**America's Power Comments on EPA's Proposal to
Repeal Specific Amendments to the Mercury and Air Toxics Standards**

Technical Comments on
National Emission Standards for Hazardous Air Pollutants: Coal- and Oil-fired
Electric Utility Steam Generating Units Review of Residual Risk and Technology

June 19, 2023

Figure 3-2. Numbers of Quarters Sampled by EPA for Use in PM Database

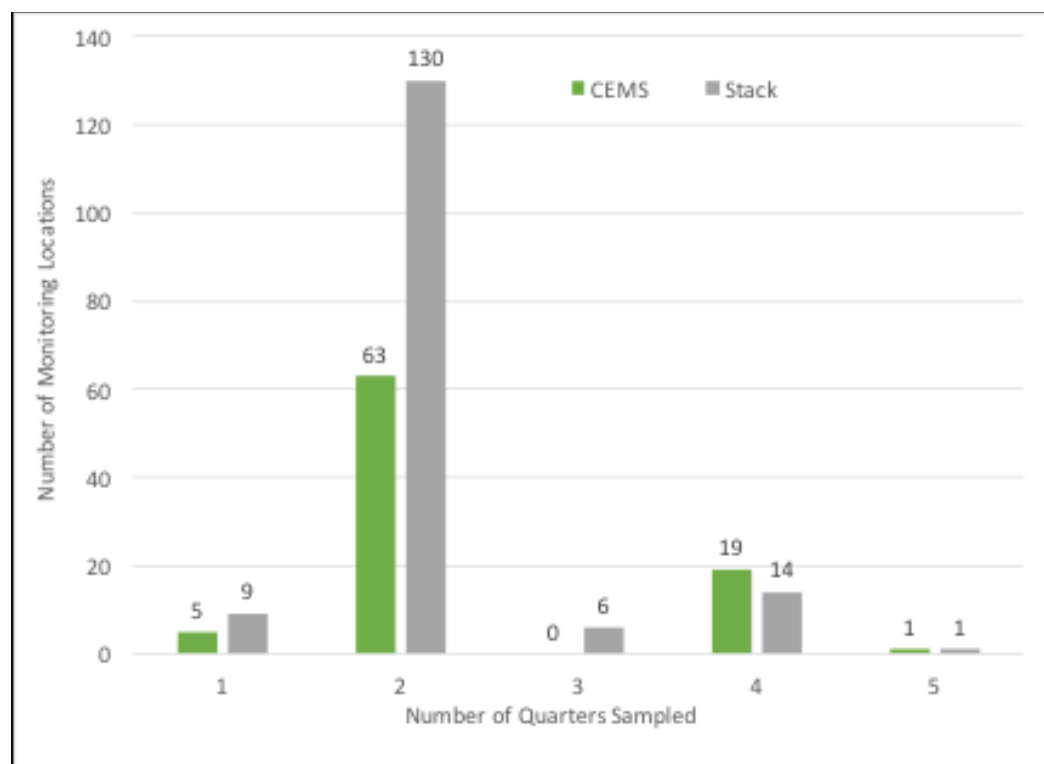
Figure 3-2 shows most monitor locations — 193 of the 245 — are characterized by only 2 quarters of data, which is inadequate compared to the 16 or 20 EPA has access to. The distribution of quarters selected by EPA according to either CEMS or stack test measurement for all 245 locations is shown. The second largest category is 33 units characterized by 4 quarters.

Of concern is the limited subset of data used for this analysis – Figure 3-2 showed that for 80% of the units the lowest is selected from only two samples. EPA states “By using the lowest quarter’s 99th percentile as the baseline, the analyses account for actions individual EGUs have already taken to improve and maintain PM emissions.”¹¹ EPA states employing the PM rate at the 99th percentile –reflecting approximately the highest data within that quarter – remedies any bias.¹²

Figure 3-3. Coronado Generating Station: 20 Operating Quarters

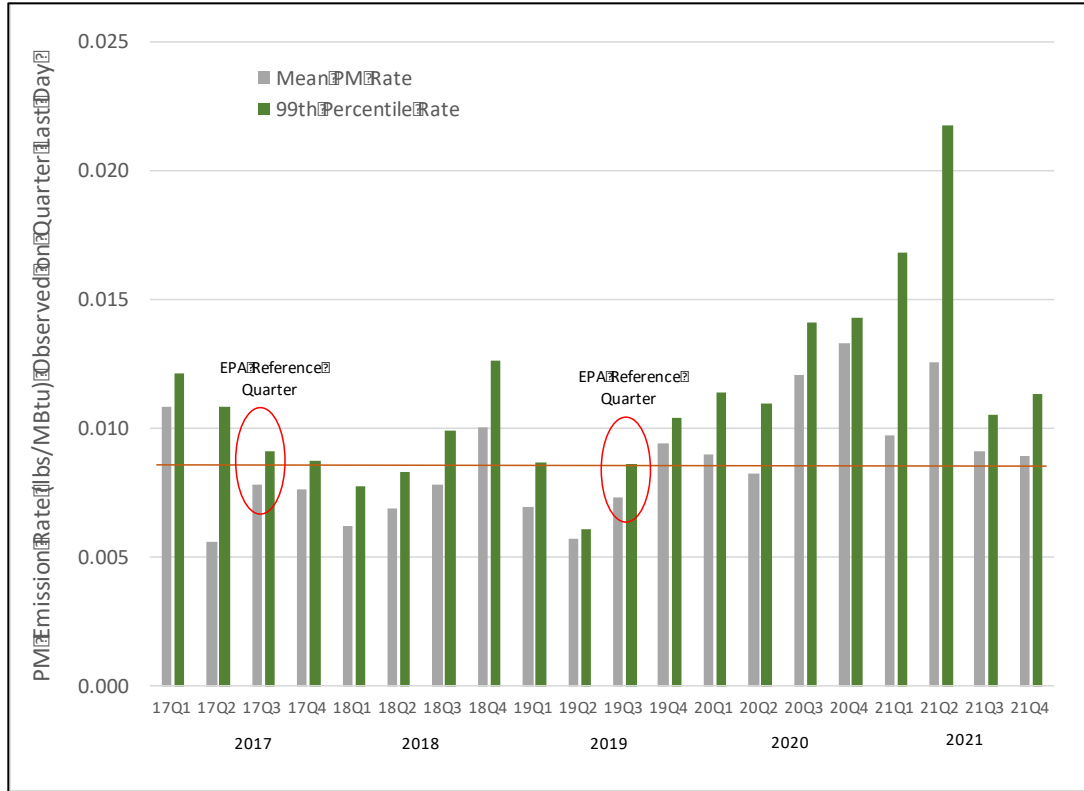
Figure 3-3 presents an example that demonstrate the shortcomings of EPA’s approach. Figure 3-3 presents PM data from Coronado Generating Station Units 1 and 2 reflecting all operating quarters from 2017 through 2021. Both the average PM rate and the 99th percentile from each quarter are presented for 20 quarters of operation over the 4-year period. Figure 3-3 also identifies the two samples EPA selected from 2017 Q3 and 2019 Q3 as representative of low fPM rate, with the latter as the “least” – and the 99th-percentile reporting 0.0086 lbs/MBtu. Figure 3-3 shows EPA’s two samples do not capture the full character of Coronado operating duty (with the red dotted line denoting the PM rate selected as representative of the units’

capabilities to control PM). These quarters as selected by EPA are far from representative of unit operations or capabilities: among 20 quarters for which data are available, the units' 90th percentile fPM rates exceed the 0.0086 lbs/MBtu rate EPA selected for 16 quarters. Ten out of 20 quarters showed 90th percentile fPM rates exceeded the proposed standard of 0.010 lb/MBtu.

Coronado Units 1/2 show how selecting the least PM rate of any quarter, and adopting the 99th percentile PM rate within that quarter, does not capture the variability in fPM emission rates, which are affected by the variability of coal and operating conditions, among others. These examples demonstrate that EPA used best-case fPM data from both compliance measures (continuous monitor and performance test data).

Figure 4-1. Fraction of Units Exceeding Three PM Rates: By Control Technology

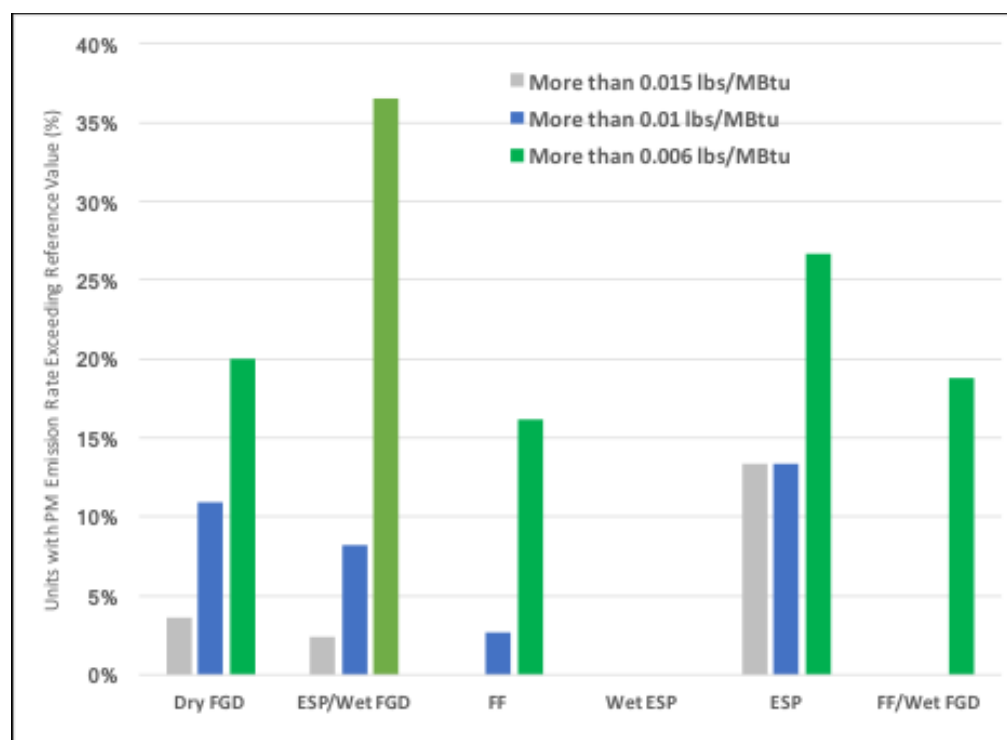
In Figure 4-1, the proportion of units in the inventory that exceed the contemplated fPM rate is proportional to the height of the bar; a higher bar implies a greater fraction of units in the inventory exceed the contemplated fPM rate. Thus:

Units in three categories exceed this highest contemplated rate – those with an ESP alone, a dry FGD followed by a fabric filter, and an ESP followed by a wet FGD. The latter category of ESP/wet FGD benefits in that actions within the absorber tower – although not designed to removed fPM – can under some conditions remove fPM. Data describing PM removal via wet FGD is sparse but suggests 50% removal can be observed.

The number of units in each of the three preceding categories exceeding this rate increases – there is no change for the category of ESP-alone, but the number of units exceeding this rate more than triple for dry FGD/fabric filter and ESP/wet FGD. No units with fabric filter/wet FGD or a wet ESP emit at greater than this rate.

Figure 6-1. Mercury Content Variability for Eight North Dakota Lignite Mines

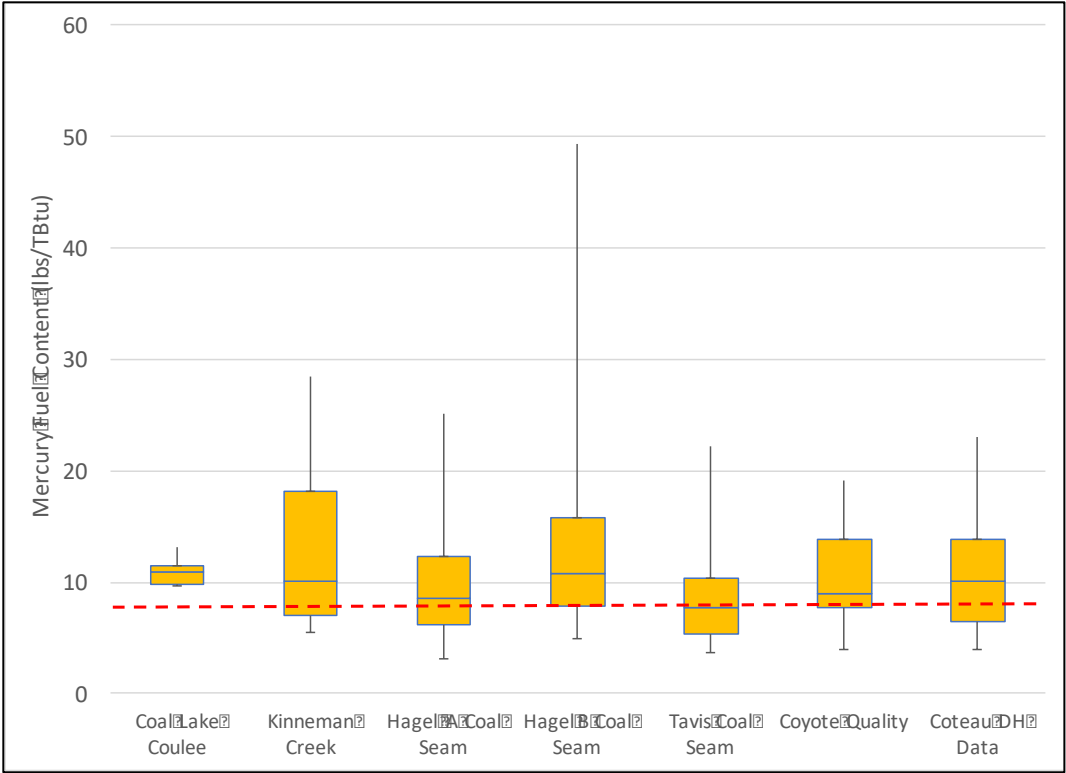
Figure 6-1 compares the Hg content and variability to the fixed value of 7.7-7.8 lbs/TBu, assumed by EPA as representing North Dakota lignite, as summarized in Table 11 of the Tech Memo. Figure 6-1 shows – with the exception of the Tavis seam – all mean values of Hg content exceed EPA’s assumed value that serves as the basis of EPA’s evaluation. More notably, the 75th percentile value of Hg for each seam - slightly more than one standard deviation variance from the mean – in all cases significantly exceeds the value assumed by EPA.

Of note is that the variability of Hg depicted in Figure 6-1 is not necessarily observed only over extended periods of time – such as months or quarters – it can be witnessed over period of days or weeks. This is attributable to the sharp contrast in Hg content of seams that are geographically proximate and thus are mined within an abbreviated time period. Figure 6-4 presents a physical map showing the location of “boreholes” in a lignite field with imbedded text describing (in addition to the borehole code) the Hg content as ppm. The text boxes report this Hg content in terms of lbs/TBu. These example boreholes – separated by typically 660 feet- and the factor of 3 to 6 variation of Hg content present a meaningful visualization of Hg variability in a lignite mine, and the consequences for the delivered fuel.

Figure 6-3. Fuel Alkalinity/Sulfur Ratio for Eight North Dakota Mines

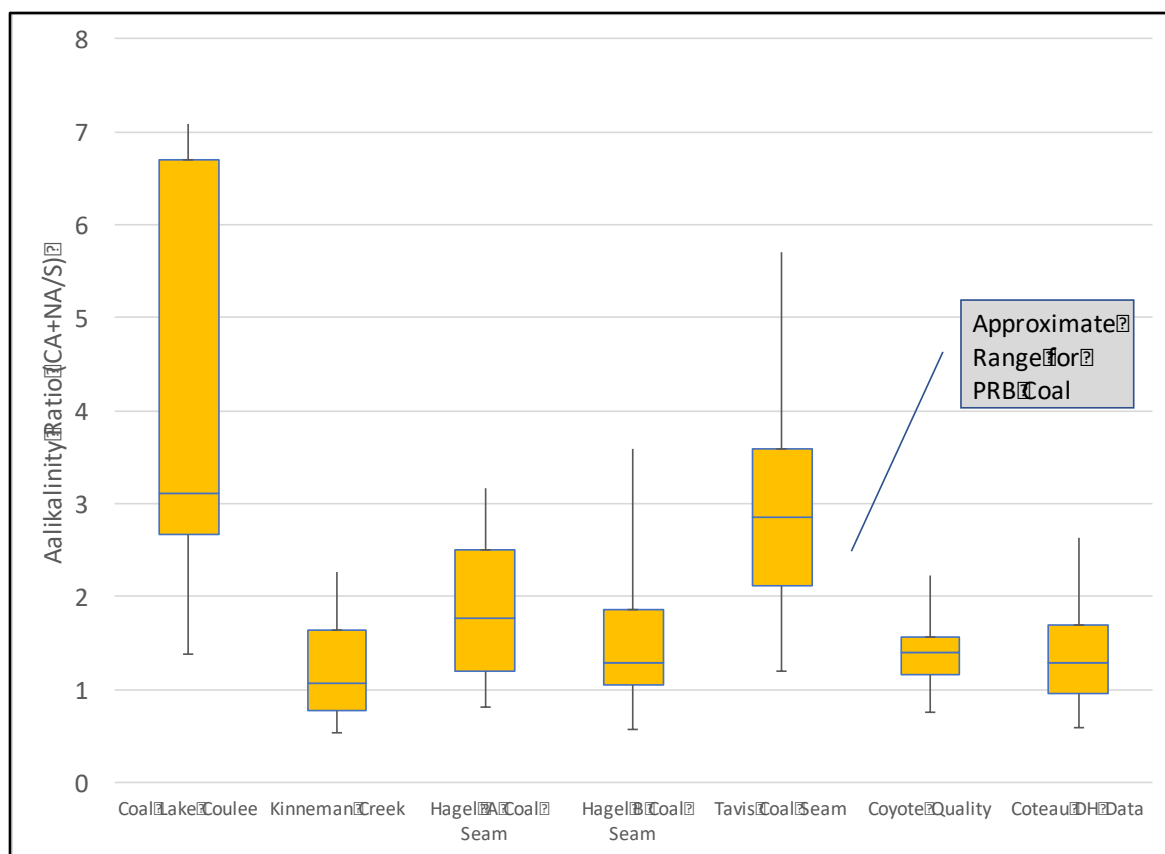
Figures 6-3 and 6-7 show North Dakota and Gulf Coast lignite present a similar ratio of alkalinity to sulfur content as does PRB – approximating a value of 2. By this metric, lignite fuels in Figure 6-3 present similar means to “buffer” SO₃ as PRB. Notably, Texas lignite in Figure 6-7 is disadvantaged in this metric as the alkalinity to sulfur ratio is half that of PRB – reducing the buffering” effect of inherent ash.

Figure 6-8. Lignite Hg and Sulfur Content Variability: 2021 EIA Submission

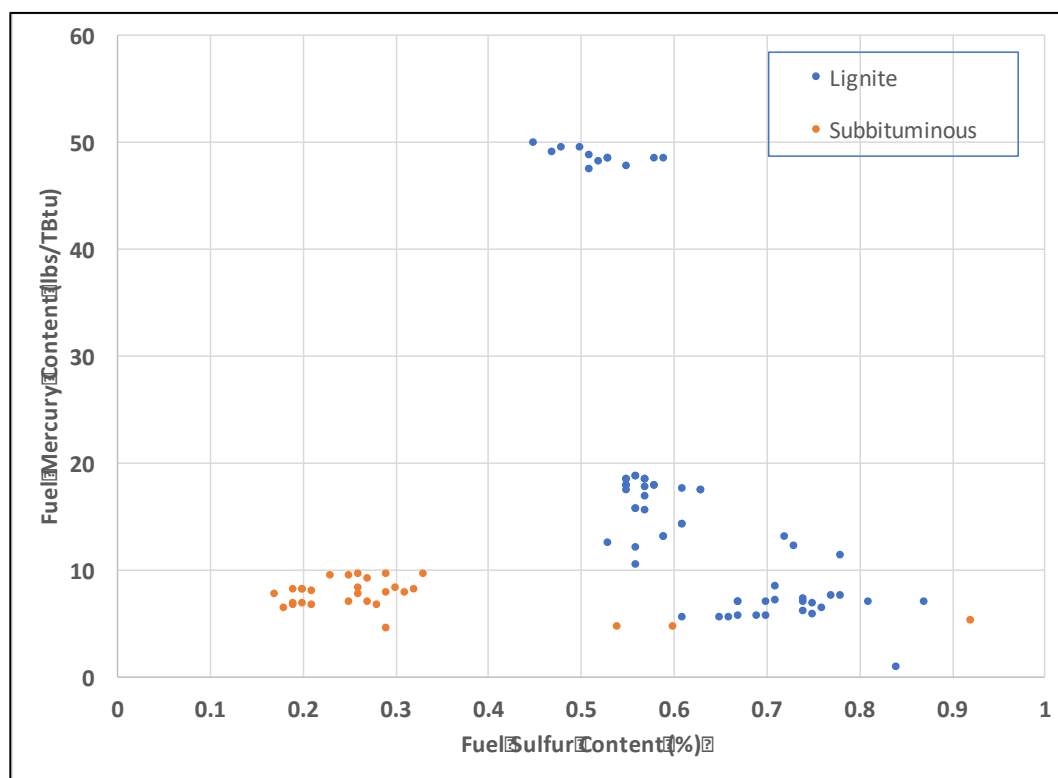
Figure 6-8 compares the seam-by-seam Hg and sulfur content from various power stations firing lignite coals, representing approximately 60 lignite mines and 40 PRB mines. Figure 6-8 shows, even excluding the outlier values of Hg (approximating 50 lbs/TBtu), lignite presents significantly greater variability in Hg and sulfur than PRB. Moreover, lignite coals have a much higher sulfur content than PRB and in many instances have twice the Hg content. The higher sulfur content of lignite equates to greater production rates of sulfur SO₃.

Figure 6-9. Sorbent Hg Removal in ESP in Lignite-Fired Unit: Effect of Injection Location

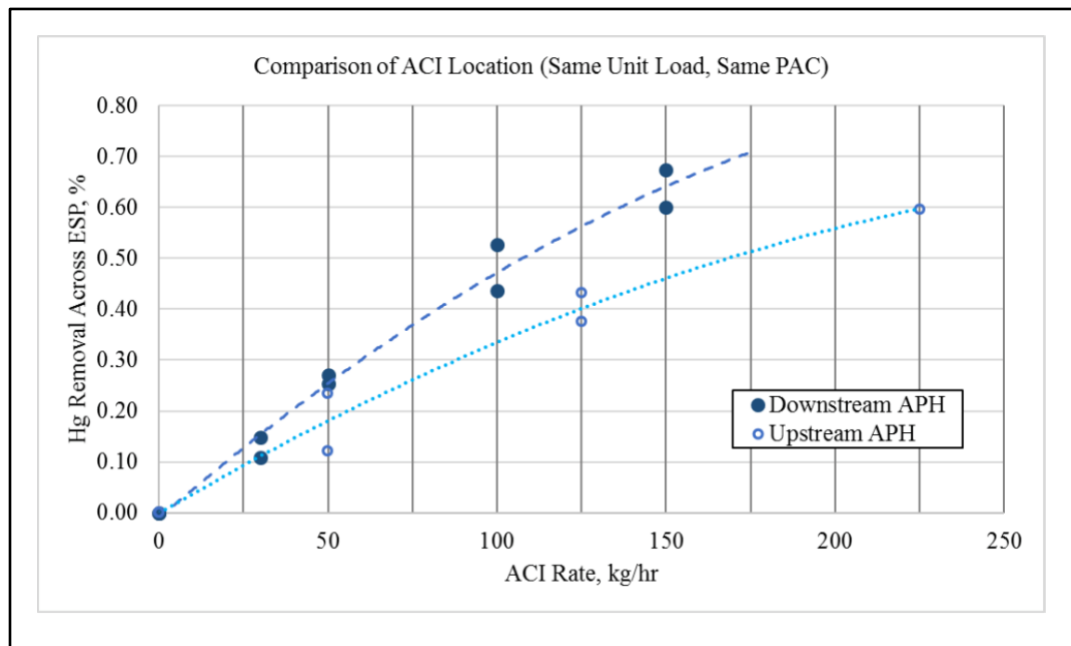
Data in Figure 6-9 show the role of SO₃ in compromising sorbent performance - highest Hg removal is attained with lower SO₃ (downstream APH) with 60-68% Hg removal achieved (at an injection rate corresponding to 0.6 lbs/MACF).

Attaining a total system 92% Hg removal – the target as described by EPA – is likely not achievable given the trajectory of the curves as shown in Figure 6-9.

Figure 7-1. Mean, Standard Deviation of Annual Hg Emissions: 2018

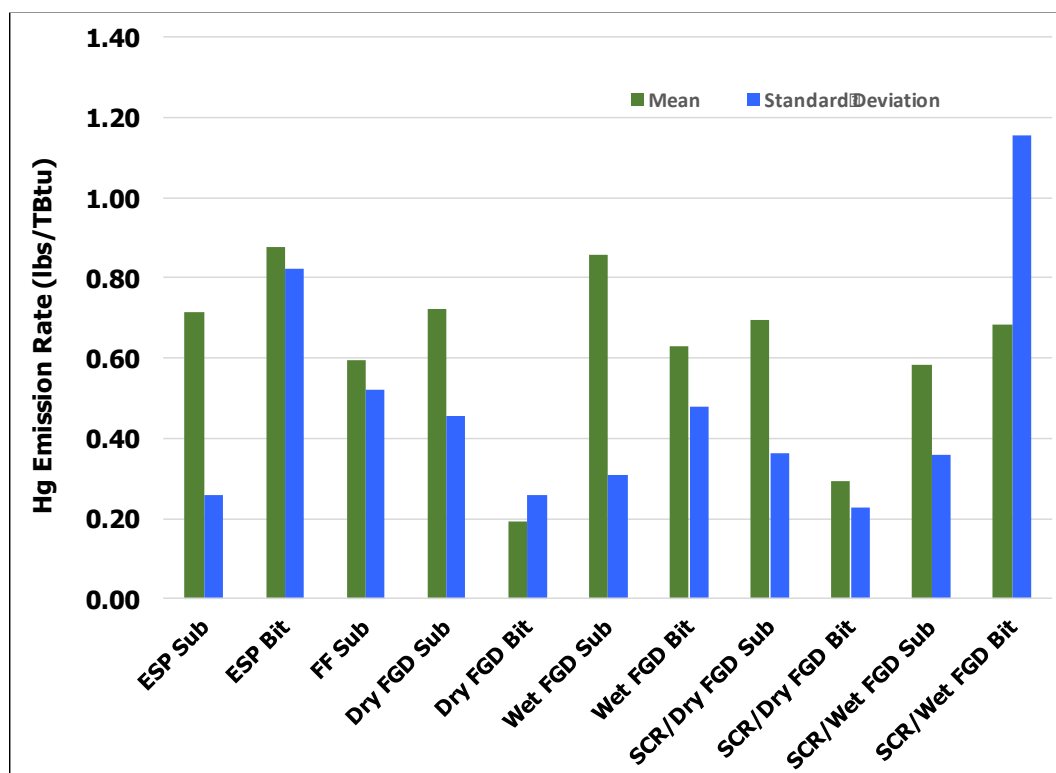
Figures 7-1 and 7-2 report two metrics of Hg emission rate variability.³⁸ Figure 7-1 presents the mean and standard deviation of Hg annual average emissions for eleven categories of control technology and fuel rank. For six of these eleven categories, the sum of the mean and the standard deviation approach the Hg limit of 1.2 lbs/TBtu.

Figure 7-2. Mean, Standard Deviation of Annual Hg Emissions: 2018

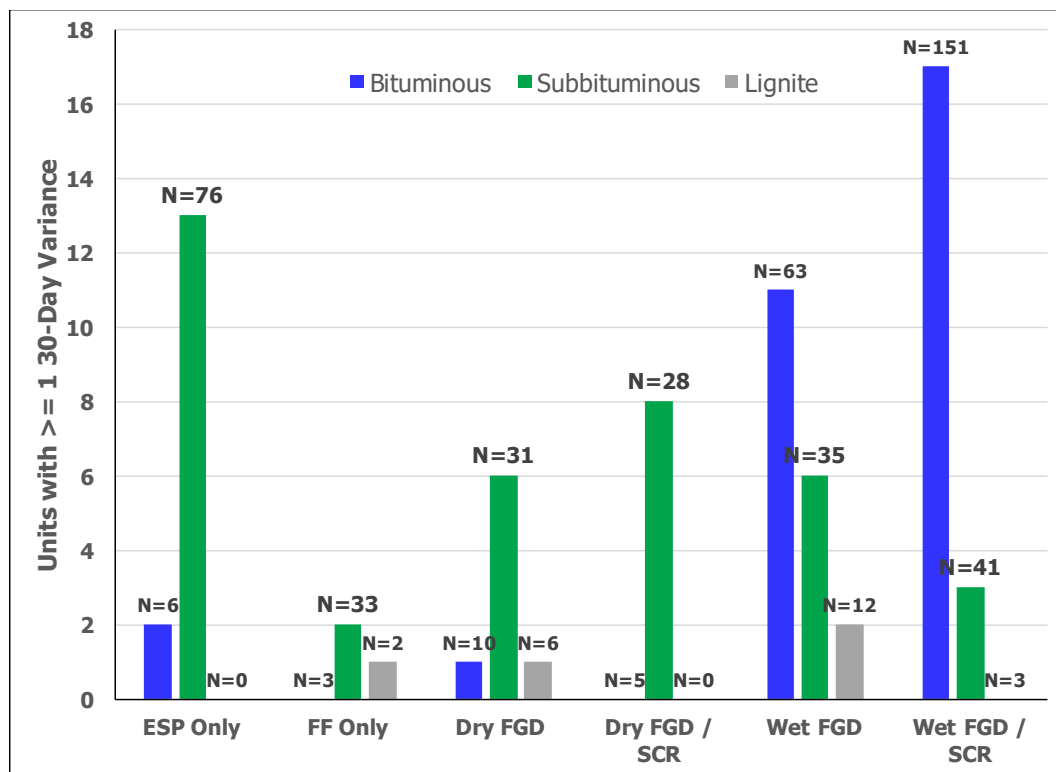
Figure 7-2 describes for six categories of control technology and 2 or 3 fuel ranks (depending on the technology) the number of units that for at least one operating day exceed 1.2 lbs/TBtu on a 30-day rolling average. Figure 7-2 shows for all categories of control technology and fuel rank experience 10% to 20% of units exceed this 30-day average.

Figure 7-3. Annual Average of Fuel Hg, Sulfur Content in Coal

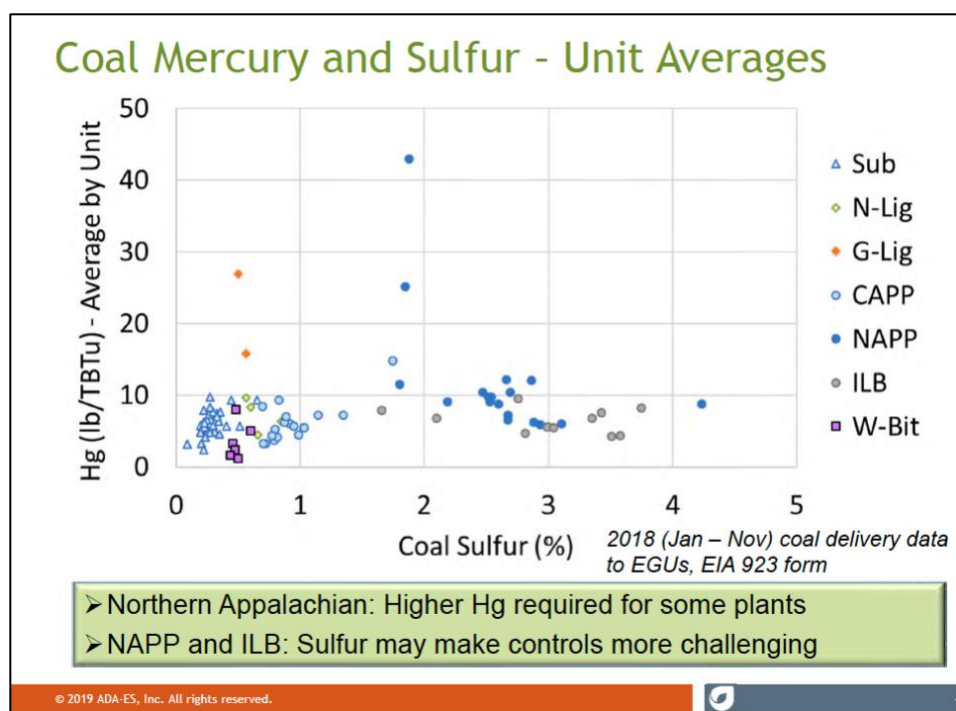
Figure 7-3 shows an average value of 5.5 lbs/TBtu does not represent either coal rank well. Figure 7-3 presents – on an annual average basis – data from more than 70 units reporting Hg content to the EIA. Numerous units report up to 10 lbs/TBtu - almost twice the average value EPA assigns, with 10 additional units reporting Hg content exceeding 10 lbs/TBtu. Northern Appalachian bituminous coals appear to contain higher Hg content than coals from other regions.
